# City of Santa Barbara California

## STAFF HEARING OFFICER STAFF REPORT

**REPORT DATE:** January 24, 2007  
**AGENDA DATE:** January 31, 2007  
**PROJECT ADDRESS:** 320 E. Victoria Street (MST2004-00511)

**A2**

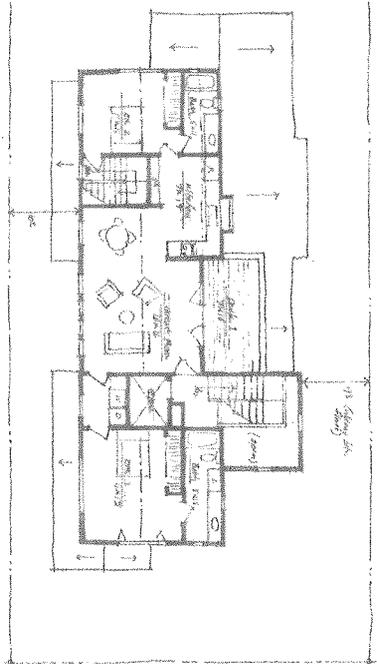
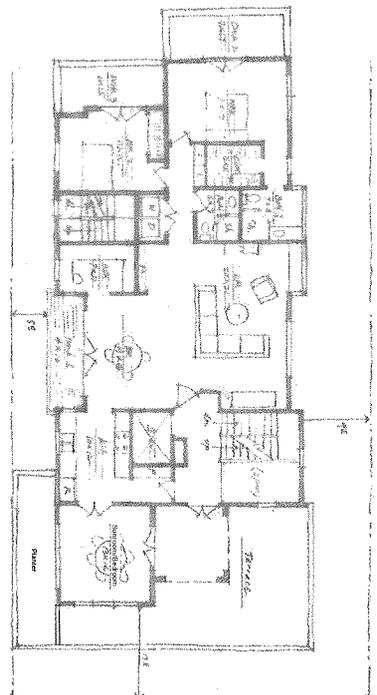
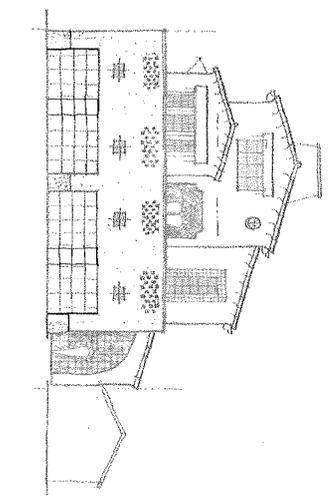
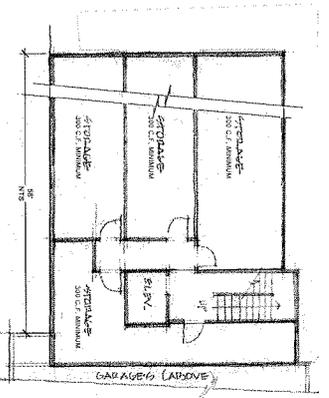
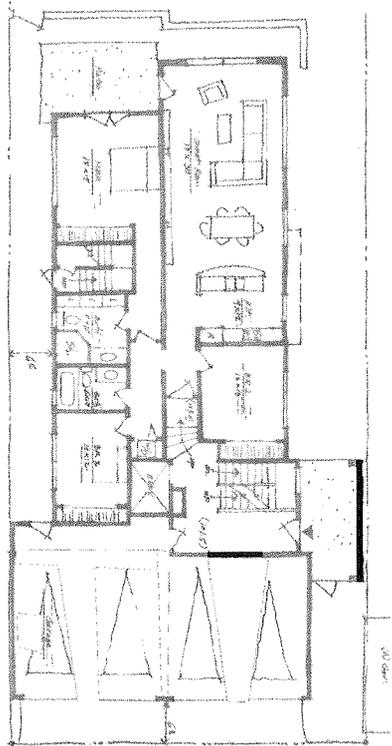
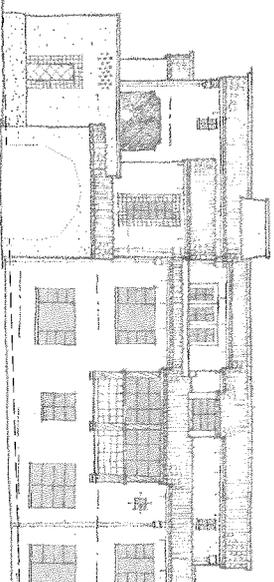
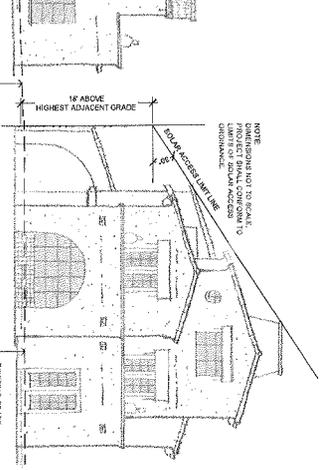
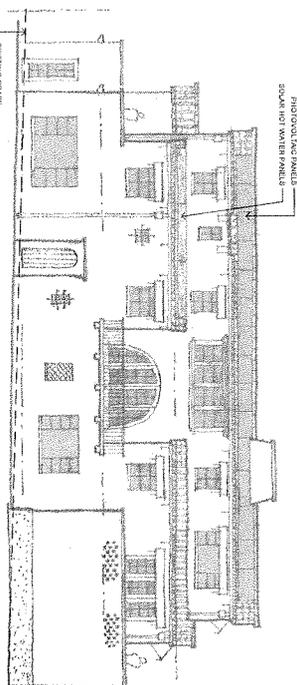
*North elevation:* the north elevation will be altered with the removal of the c. 1900 Colonial Revival porch and its replacement with an eight foot deep wing and an 8' x 12' porch in the Italianate style, topped by a deck with a simple balustrade running along the entire façade. A new double-hung window will be added on the second floor (See Sheet A2).

*East elevation:* the east elevation will be altered with the removal of a paired window on the first floor and a single window on the second floor and their replacement with an exterior brick chimney flanked by double hung windows (See Sheet A2).

*South elevation:* the later non-character-defining additions will be removed from the rear of the existing Victorian house, and will be replaced with two two-story cross-gabled wings which will tie into the existing side-gabled roof of the main block of the house. The new square footage will be 2426 square feet (See Sheet A2).

*West elevation:* the west elevation will be altered with the addition of a double-hung window adjacent to the existing window on the first floor. Solar panels will be added to the west slopes of the gable roofs of the proposed new two-story wings (See Sheet A2).

1. These comments are predicated on conceptual drawings. Final plans delineating the amount of wood to be removed, the design of the chimney, the porch columns and porch and deck railings, and the roofing material for the Victorian house shall be reviewed by an architectural historian and a letter addendum prepared prior to work taking place.
2. The proposed exterior chimney shall be made as slender a profile to the street elevation as possible to be compatible with the Italianate style.
3. . The main residence shall be documented according to the City's "Required Documentation of Buildings Prior to Demolition" prior to the demolition. Two copies of the archival
